WATERSHED PROTECTION DEPARTMENT

Project Name: Flatiron Forest – Mt Gilead Parcel # 2014 & 2037

Subject Features: One (1) ephemeral stream, one (1) intermittent stream segment, one (1) perennial stream segments, and six (6) potential wetlands

Date of Determination: June 2, 2022

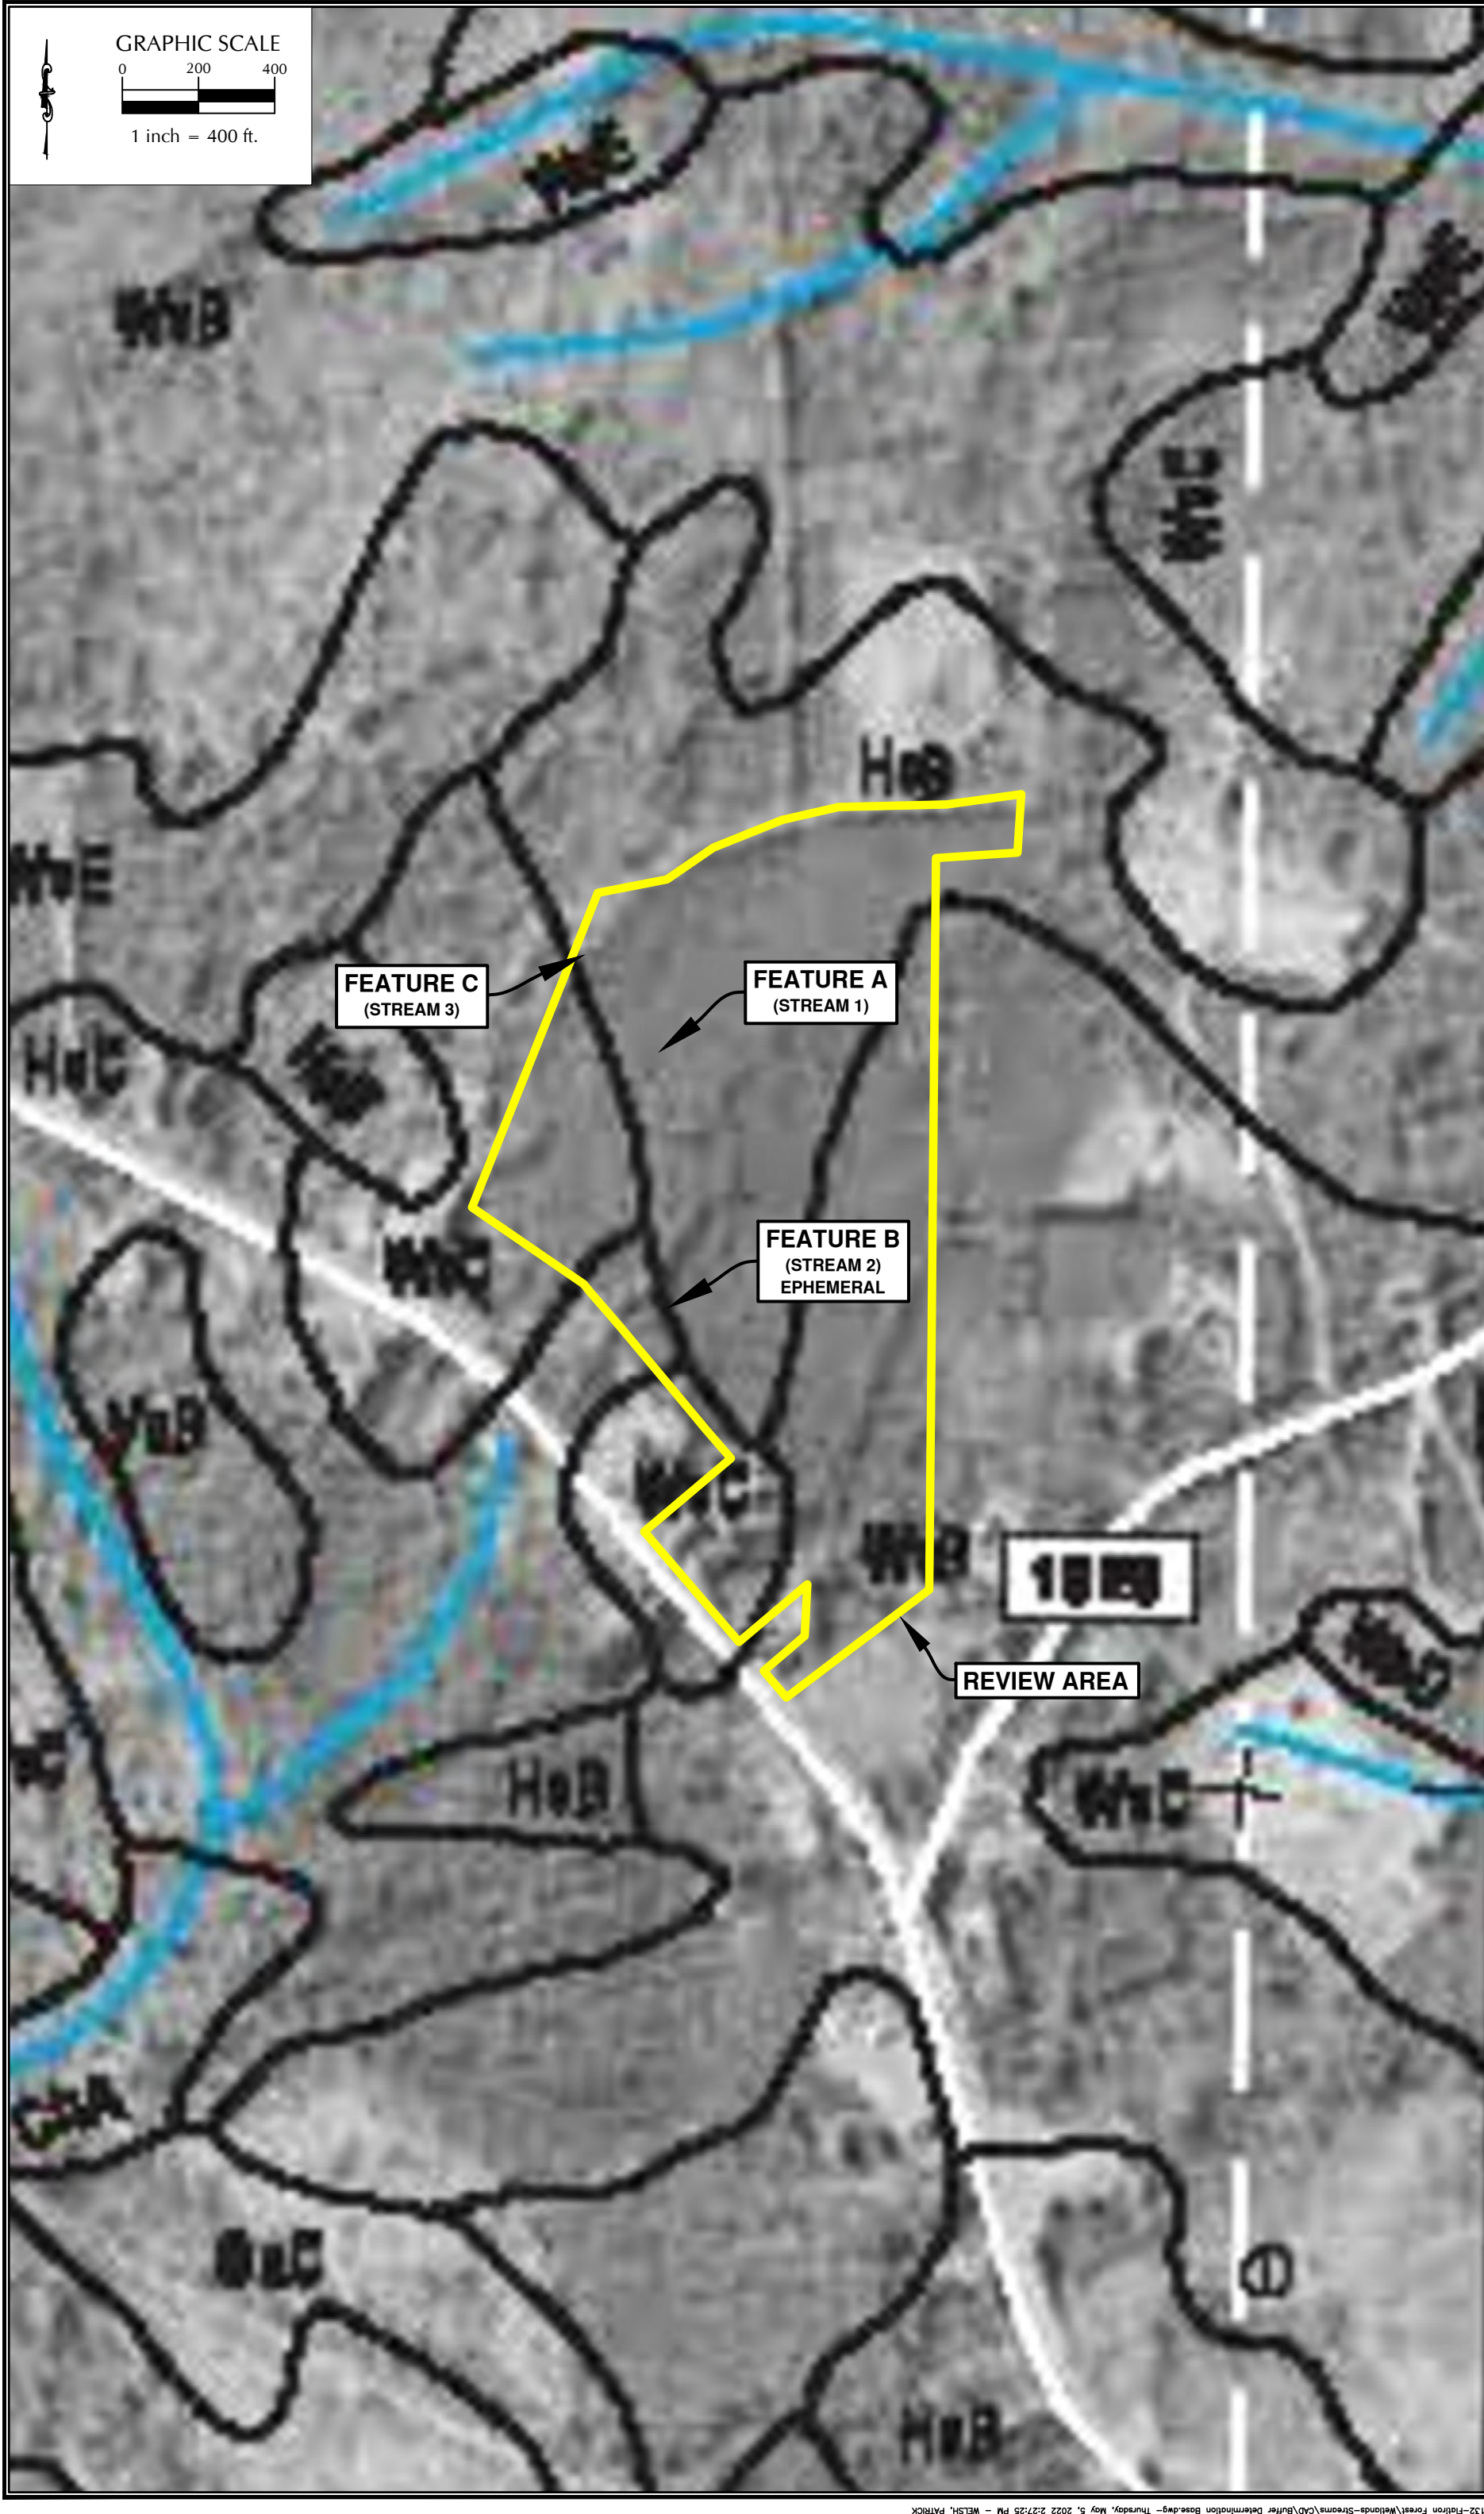
All points of origin, stream type transitions, and wetland boundaries were reviewed and agreed to in the field by all parties in attendance. One ephemeral stream segment (Feature B – Stream Form 2A) was removed as the segment did not meet the required 10 points for ephemeral streams.

All ephemeral stream segments will require a 30-ft buffer from the top of bank landward on both sides. All intermittent stream segments will require a 50-ft buffer from the top of bank landward on both sides. The perennial stream segment will require a 100-ft buffer from the top of bank landward on both sides. A 50-ft buffer will be required on all wetlands from the flagged boundary landward.
